AGENDA
PLANNING & ZONING COMMISSION
City Commissioner's Room
118 S. Cage Blvd. February 12, 2018 – 6:00 PM

DATE: MONDAY, FEBRUARY 12, 2018
TO: PLANNING AND ZONING COMMISSION
FROM: DEVELOPMENT SERVICES

DETAIL A Lot # 74

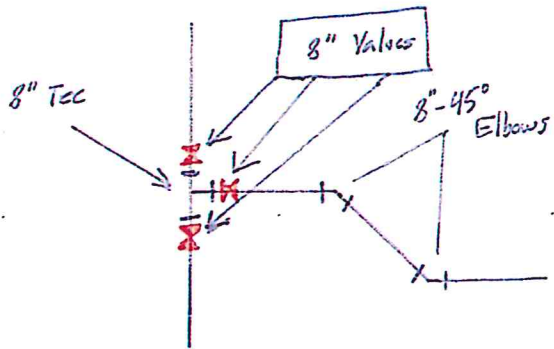
- Will need 2 Valves on lot #74 (Detail A)
- Will need water service for lot # 1
- Will Need valve on lot #86 (Detail B)
- Will need to show details to Distribution connections on Ridge Rd.
- Will need water Valve in main line on Ridge Rd. for isolation purposes (Detail C)
- Will need 2 water valves to be on main line to lot #85 (Detail D)
- Water valves to be on main line for fire hydrants (Detail E)
- Follow City of Pharr Construction Standards Manual
